Our ref: 22SUT-1783

Macquarie Park, Ivanhoe Estate –Tree Advice Letter

Figure 2: Crib wall scope assessed within ELAs AIA (dated 28 February 2020)

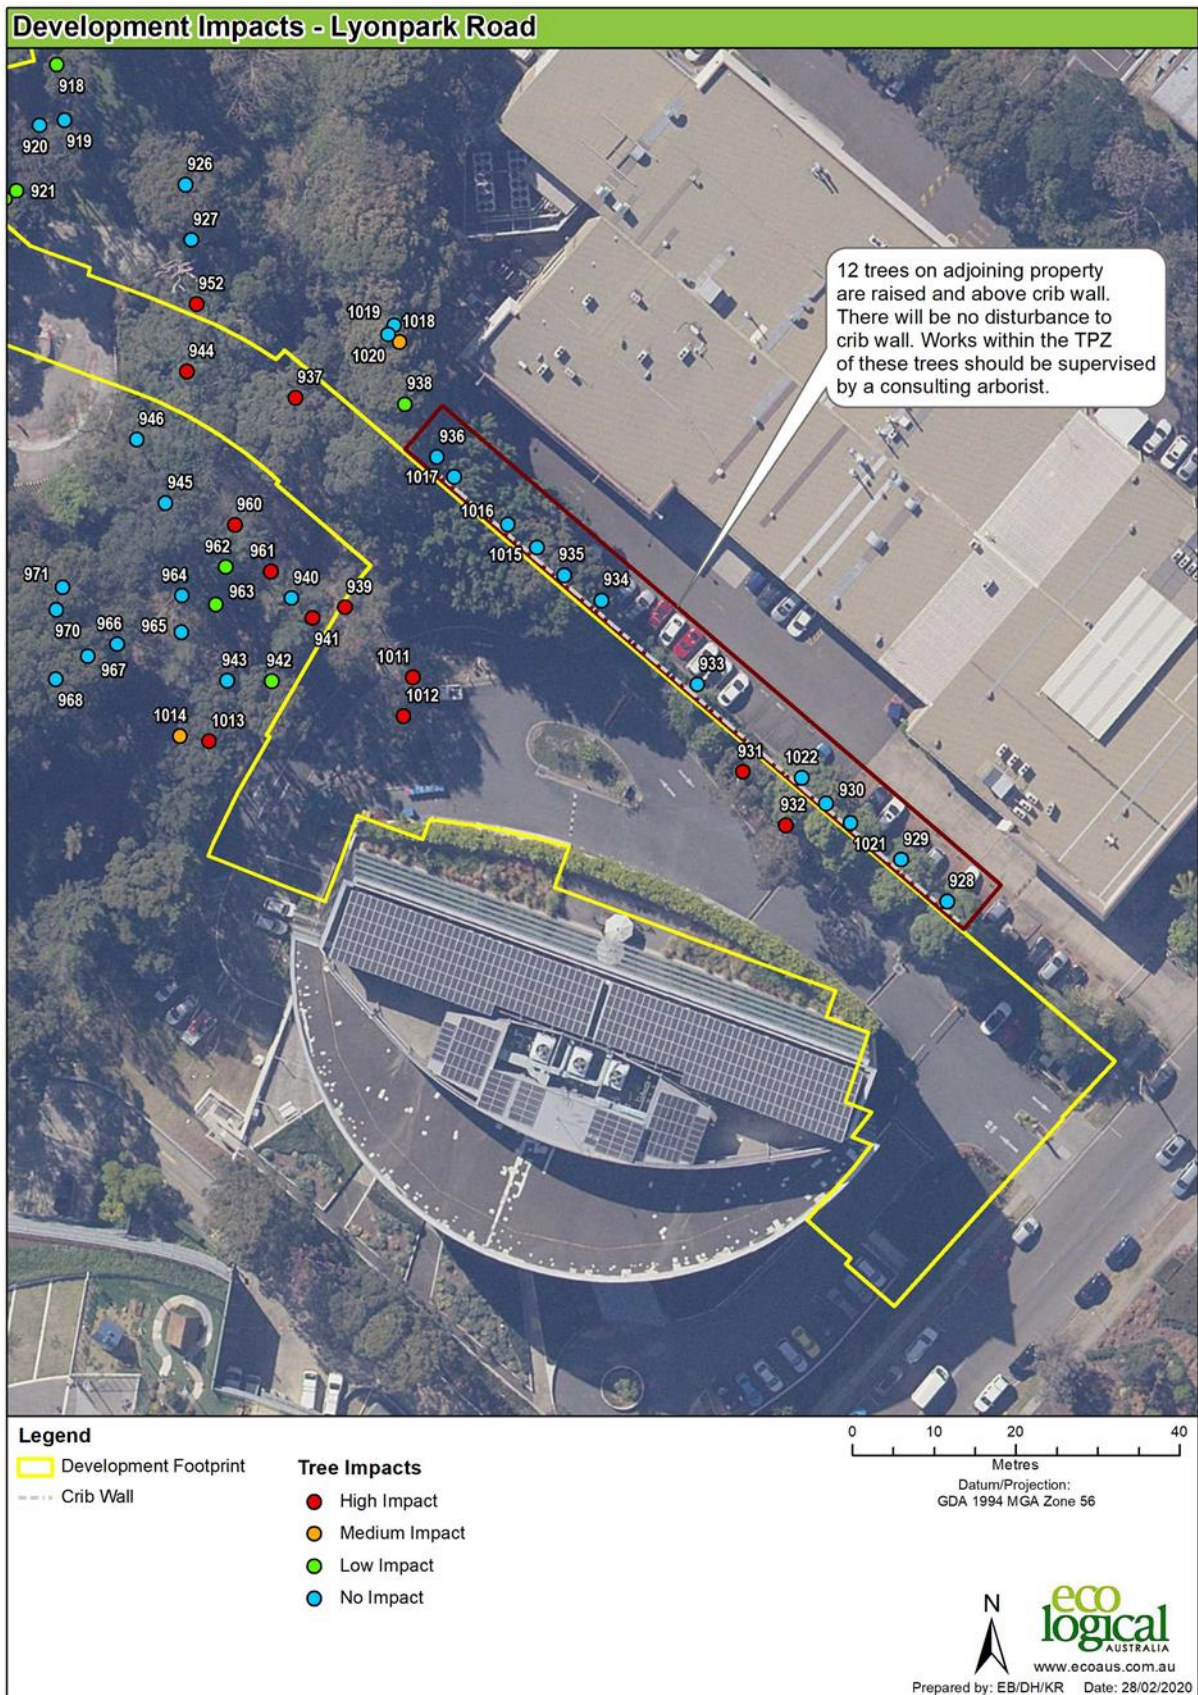
The previously assessed impact area and assessment outcomes are shown in Figure 2 and 3. The original assessment (ELA 2020; AIA v6) indicated the seven trees in question could be retained as they were located above the crib wall, situated 2+metre above the proposed footprint, as advised by the client. Based on the detailed plans (ADW Johnson 2018) and client discussion disturbance of the structural root zone was not expected to occur.

Due to changes in the ground level necessary to facilitate the provisions of the new roadway, excavation of the embankment adjacent to the crib wall to a depth of approximately 3 metres from the current level, the structural root zone of these trees will now be impacted. This is compounded by the growth of the *Ficus* and other trees, which have adapted to their surrounds and utilised the lower embankment for their structural root zone.

If the proposed roadway is to be constructed as per the current design, the southern root plate of the trees will be impacted, possibly destabilising their structural integrity and ongoing viability. The structural integrity of the crib wall is also of concern due to disturbance of the crib wall footings, associated with impacts to tree roots and excavation.

Although *Ficus microcarpa* is a resilient species, due to the tree locations, differing ground levels between properties, the location of the root plate location and the destabilisation of both the trees and boundary walling, for excavation works to proceed, all seven trees will require removal.
